SUBJECT: Transmittal of Revised Responses to AP1000 DSER Open Items

**AP1000 Design Certification Review
Draft Safety Evaluation Report Open Item Non-Proprietary Responses**

DSER Open Item Number: 3.6.3.4-2 Addendum 1 Revision 2

Figure 1 – Core Collapsed Liquid Level (%)

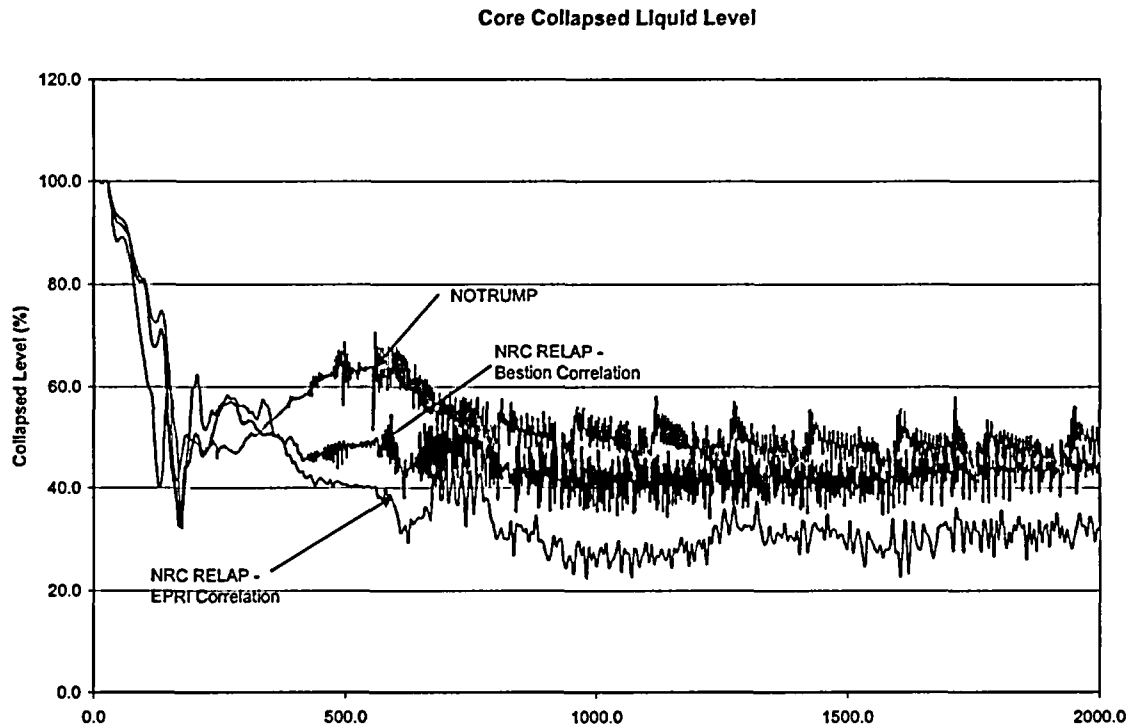
Figure 1 provides the core collapsed liquid level comparison. This shows the effect of the interphase slip model in RELAP. Comparisons of the correlations to experimental tests are reported in Reference 1. In Reference 2 it is shown that the Bestion correlation predicts a lower interfacial drag than the EPRI correlation used in the base RELAP case, and hence more water is predicted in the rod bundle when the Bestion correlation is used. RELAP with the Bestion rod bundle correlation provides results that compare better to the NOTRUMP calculation.
